October 9, 2024

Land Use Case File LU-0014-2024 1360 SW 257th Drive.

FILE NUMBER / NAME	LU-0014-2024 Cherry Park East Luxury Apartments		
APPLICATION TYPE	Type III Variance, Site Development Review		
PROJECT APPLICANT	Tracy Brown	PROPERTY OWNER	Mike Halstead
PROJECT LOCATION	1360 SW 257th Ave	TAX MAP / TAX LOT #	1N3E35AA -05717
COMPREHENSIVE PLAN DESIGNATION	High Density Residential	LAND USE ACTIVITY	Multi-Family Development
ZONING DISTRICT	HDR - High Density Residential	OVERLAY DISTRICT	None

EXISTING CONDITIONS
 1360 SW 257TH AVE
 TROUTDALE OR 97060

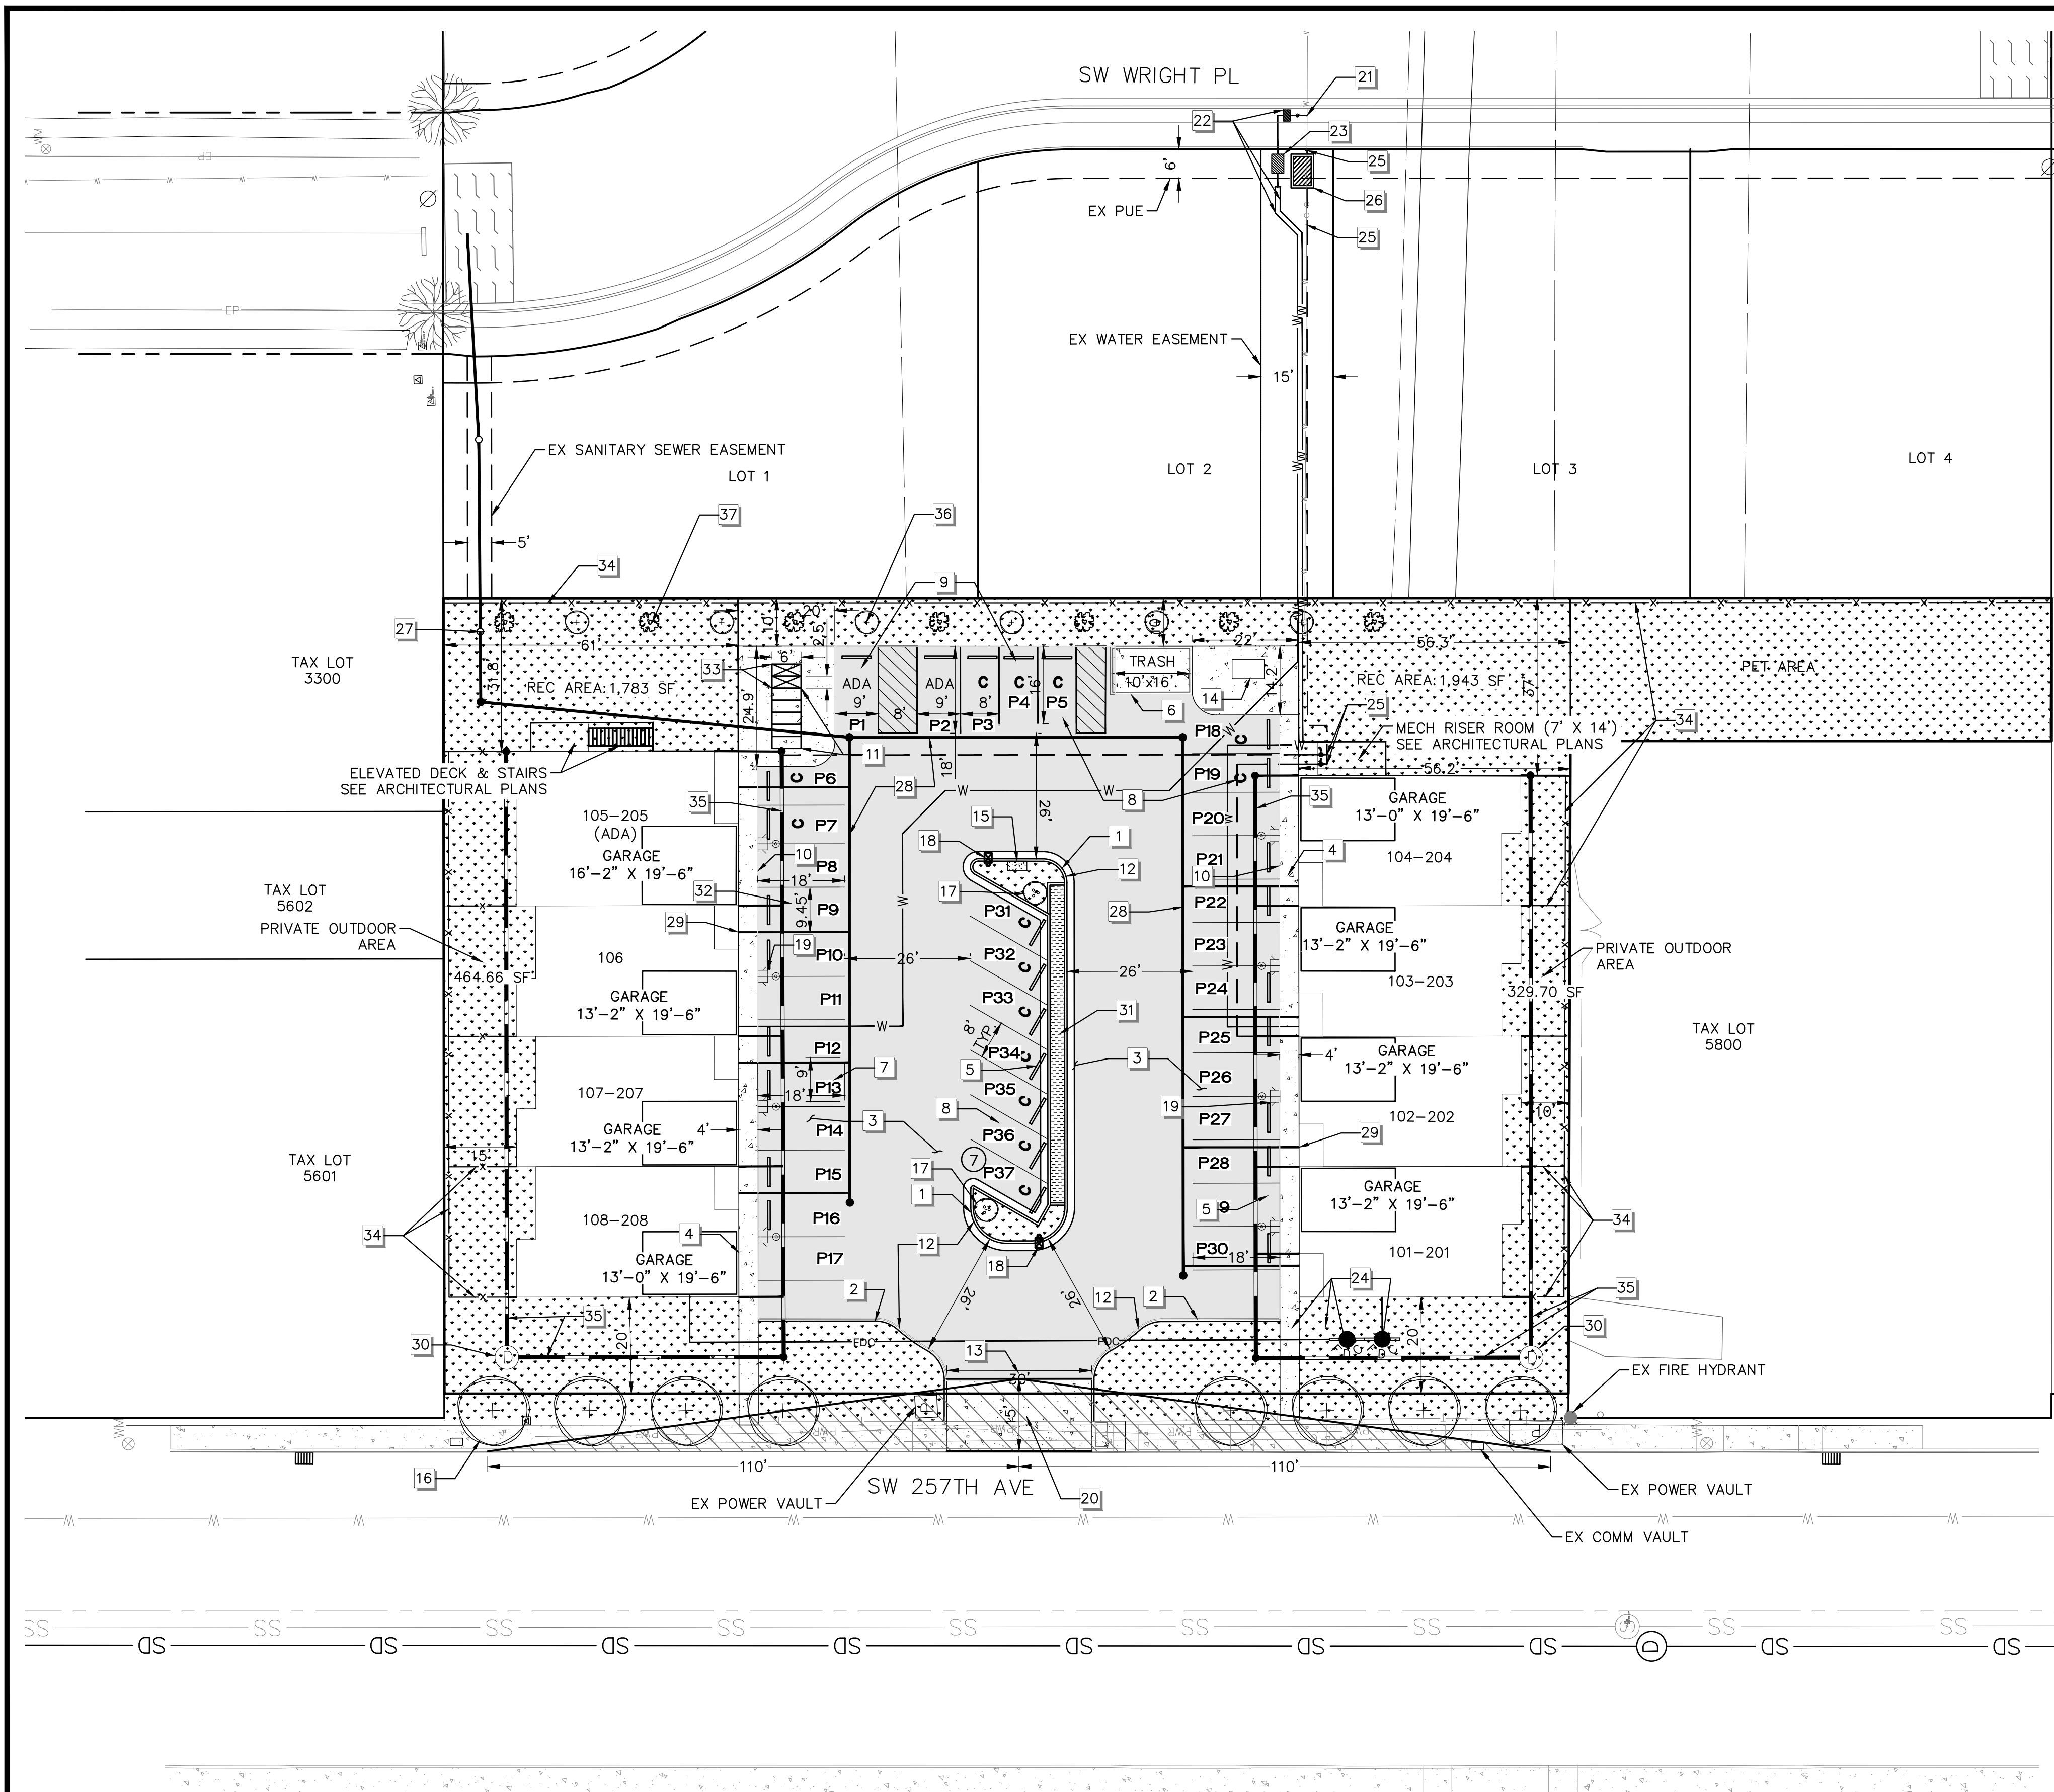
Finding 23: The site plan shows a 10x16 sq ft trash and recycling enclosure that is constructed with wood fencing and a latching gate. The applicant's narrative and plans do not include details regarding the height of the fence. Per the above provision, the height of the garbage and recycling enclosure shall be six feet in height. **As such, this criterion can be conditionally met.**

3. Per 8.060(A)(6) and (7), a landscaping plan shall be required at the time of building permit submittal.
4. Per TDC section 8.060(B)(1) further detail is needed regarding the trash and recycling enclosure at the time of building permit submittal. Specifically, the applicant needs to specify the height of the fence surrounding the enclosure.

Front Elevation
1/4" = 1'-0"

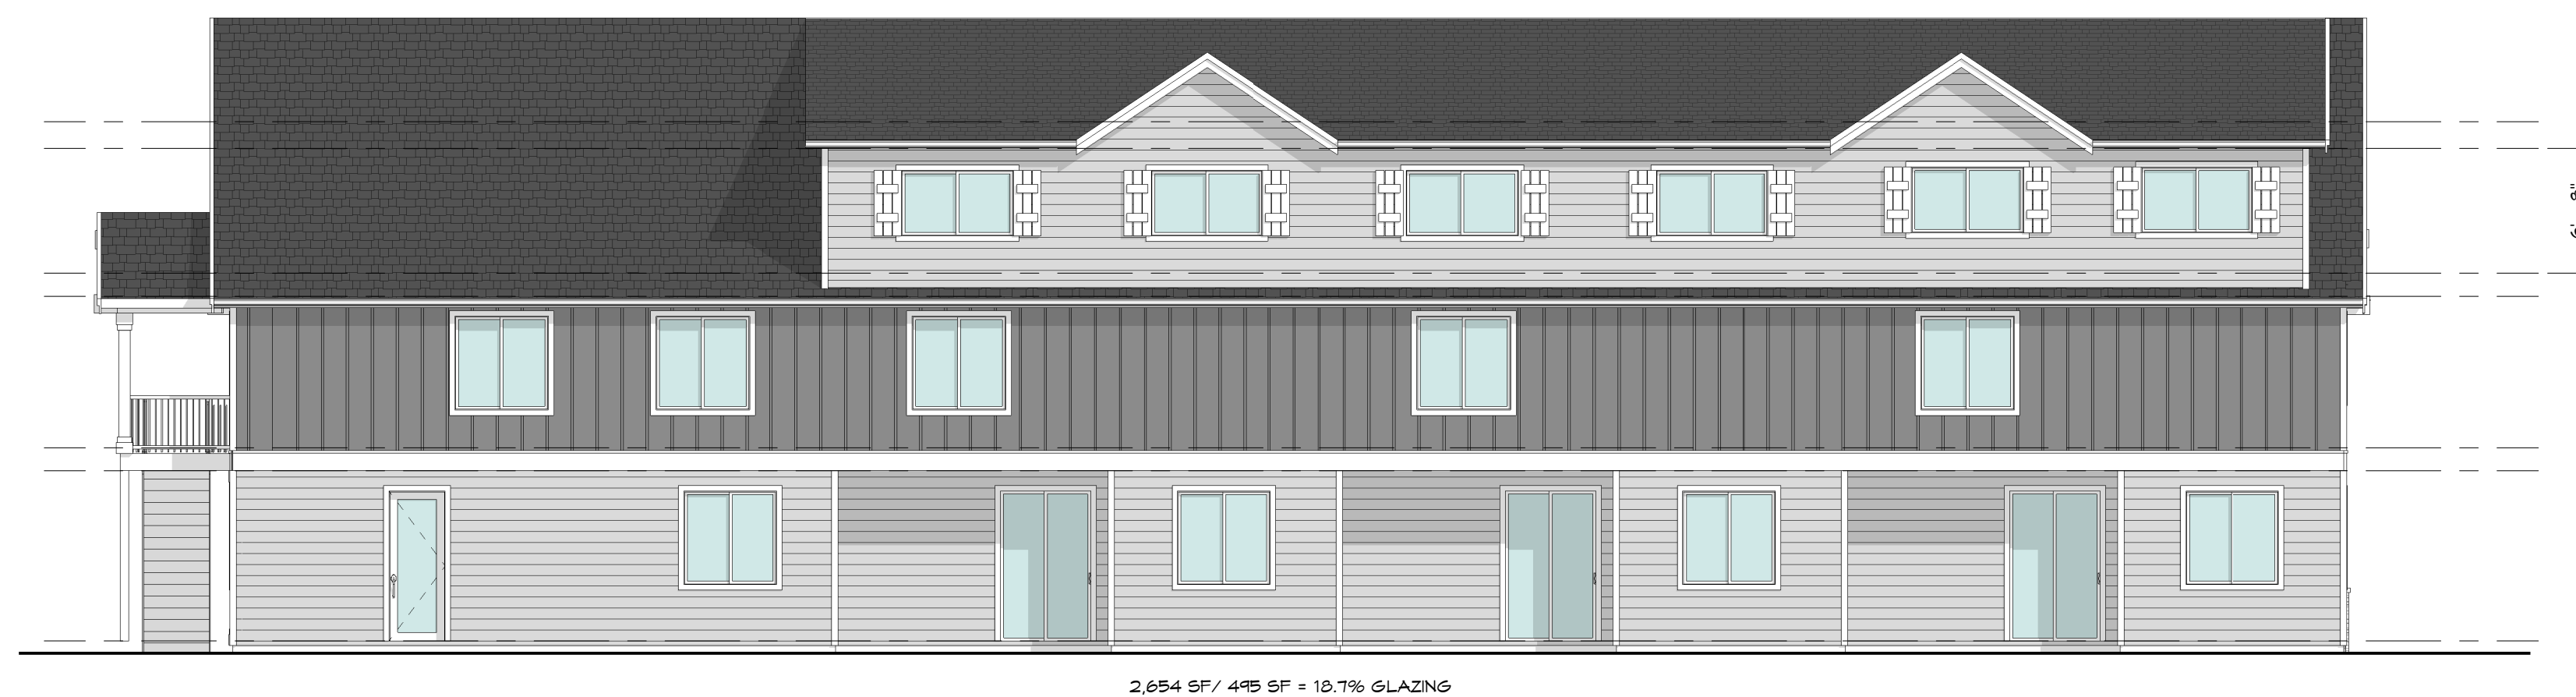
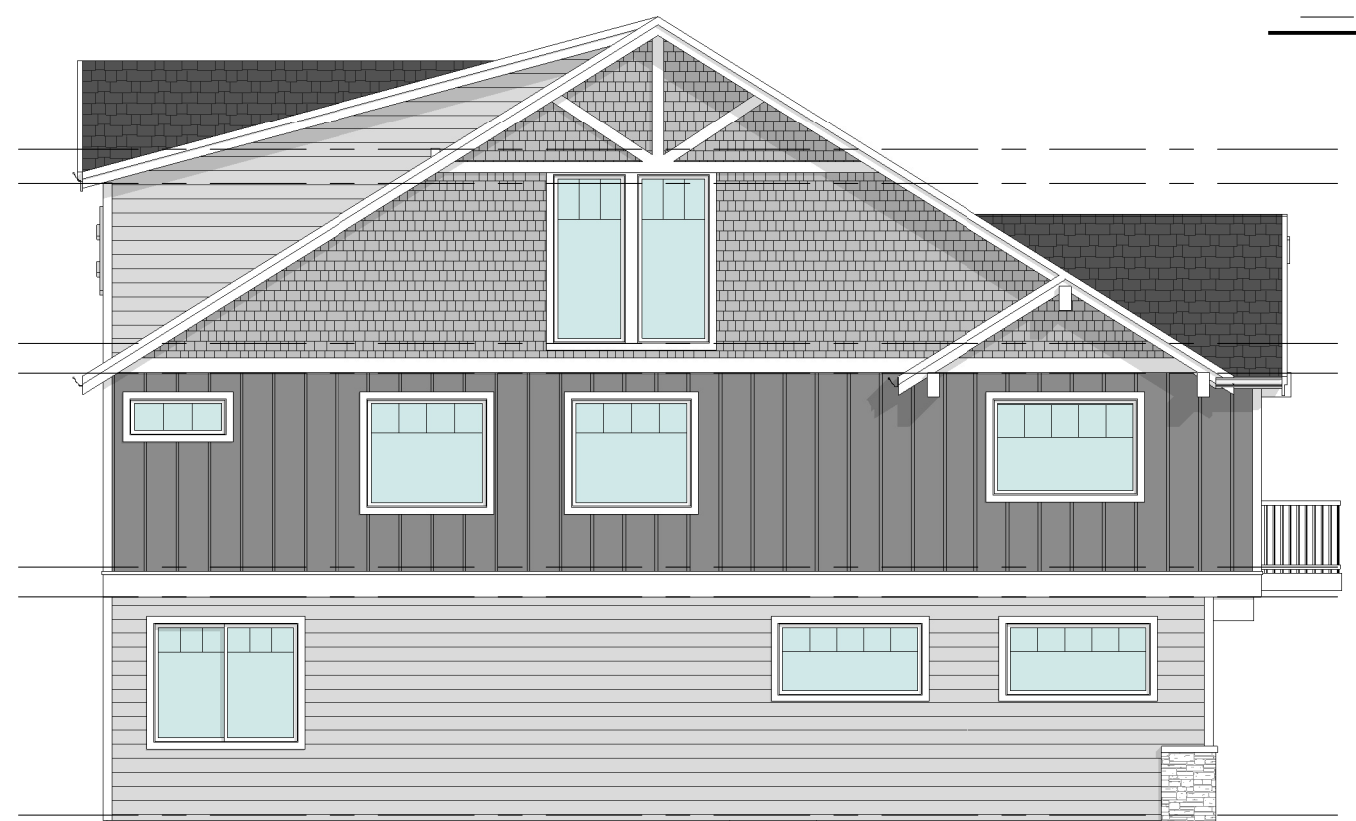
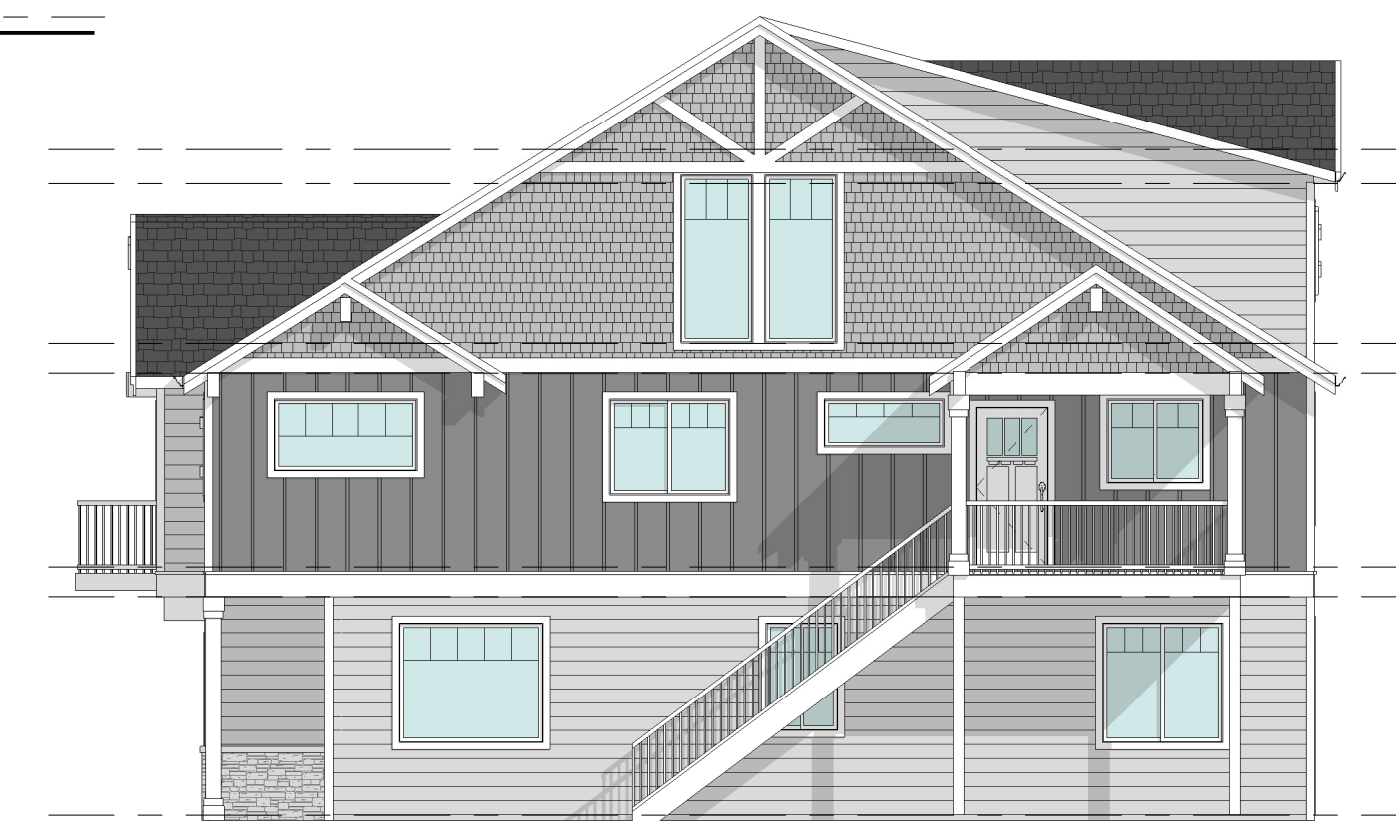
Finding 36: Per the submitted architectural elevations, the building facing the public street does not contain at least three of these elements. The applicant shall revise the side of each building to ensure three of the listed items are being met. **As such, this criterion can be conditionally met.**

6. Per the requirements of TDC 9.060 and Troutdale Municipal Code 8.26, a lighting plan shall be required at the time of building permit submittal
7. Per TDC 8.150(B)(4)(b), further detail is needed at the time of building permit to show at least three architectural elements on all building walls that face SW 257th Ave.
